Harmonised Ancillary Services 2013/2014

Recommendations Paper

4th July 2013

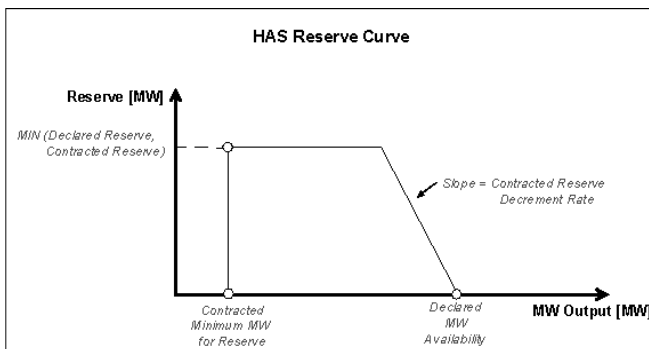
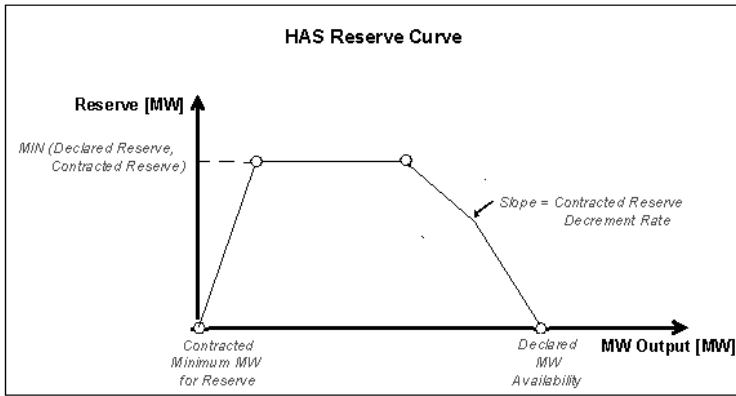
One respondent (SSE) mentioned it was unclear of the TSOs' intention in relation to the proposal and believes the current regime already captured the effect described as being available within the existing Northern Ireland settlement system and therefore request further clarification from the TSOs.

Having reviewed the discussion in the section, it is not clear to us what the TSOs hope to achieve with the Decremental Operating Reserve rates. We would consider that the scaling factor in the current payment regime would capture the effect described as being available within the existing Northern Ireland settlement system. Perhaps the TSOs could clarify this matter.

The TSOs would like to clarify the existing decrement rate is a slope of contracted reserve decrement rate and it is the TSOs' intention to introduce multiple break points in the reserve curve which may result in different slope characteristics to reflect unit output capability.

The TSOs will review the design of decrement rate methodology for implementation. The TSOs envisage the implementation of this review will not be made available to providers in 2013-14 tariff year.
